VCS VERIFICATION REPORT

CECIC HKC GANSU CHANGMA WIND
POWER PROJECT

(VCS PROJECT ID: 717)

Project Title	CECIC HKC Gansu Changma Wind Power project
Version	01
Report ID	CTISC-NC-CBN-20221001

Figure 1 Project boundary of the registered CDM PDD

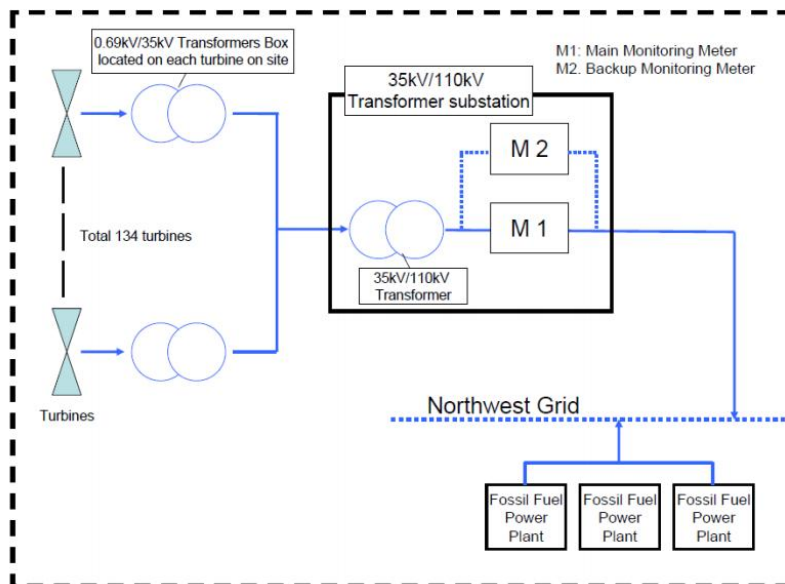
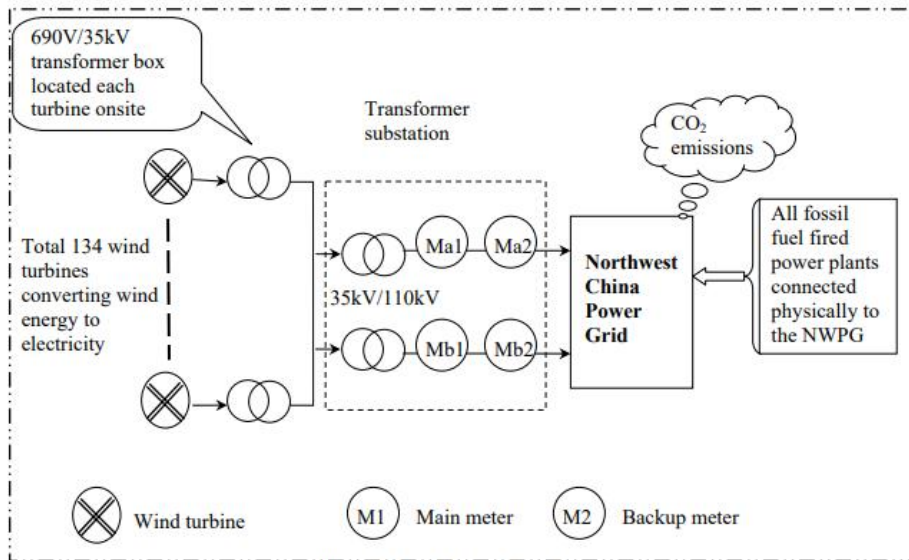
There is a project description deviation in relation with type of wind turbines and electricity metering system of the project activity. By checking the revised CDM PDD approved by CDM EB, it was identified that:

1. In the registered CDM PDD, the type of wind turbine is FD77/1500 while in the revised CDM PDD, the same has been revised to FD77A/1500.

2. In the registered CDM PDD, the project boundary involves electricity meter M1 and M2 and the electricity was delivered to the grid via one 35kV/110kV transformer, while in the revised CDM PDD, the project boundary involves 4 electricity meters Ma1, Ma2, Mb1 and Mb2 and the electricity was delivered to the grid via two 35kV/110kV transformers. Please refer to figure 1 and 2 below for detail.

The verification team confirmed that this deviation will not lower the accuracy and conservativeness of the monitoring system and the project remains in compliance with VCS Program rules and this deviation has no impact on the applicability of the methodology, additionality or the appropriateness of the baseline scenario and meet all appropriate rules and requirements of VCS standard. Besides, the revised CDM PDD has been approved by CDM EB on 27/11/2012.
